# City of El Paso - City Plan Commission Staff Report

Case No: SUSU13-00060 Mission Ridge Unit Six

**Application Type:** Major Final **CPC Hearing Date:** August 8, 2013

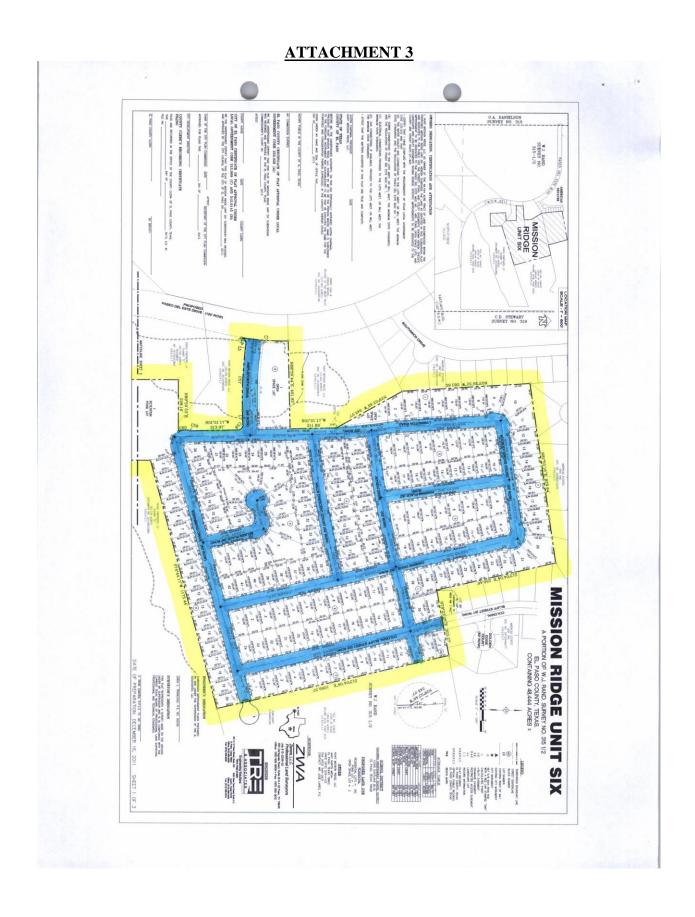
- 1. Developer / Engineer shall comply with section 18.60 Flood Damage Prevention of the El Paso Municipal Code and FEMA requirements.
- 2. Show BFE elevation lines within flood zone limits.
- 3. Applicant shall coordinate with the U.S. Army Corps of Engineers for the requirements and compliance of the Clean Water Act; 401 and/or 404 permits may be required.
- 4. Applicant shall comply with section 19.19 Preservation of Natural Arroyos.

The El Paso County District request four changes made in MISSION RIDGE UNIT 6 PRELIMINARY PLAT.

- 1. Convert 5 digit addresses to 3 digits in Section 10 lots 1 and 2. Have them be in the 800 range.
- 2. 800 range addressing in in streets north of AITKEN DR. See Sections 2 & 3.
- 3. Convert BELKEN PL 5 digit addresses to 3 digits, in the 700 range.
- 4. Rename EDDINGBERG DR because a same sounding street name exists.
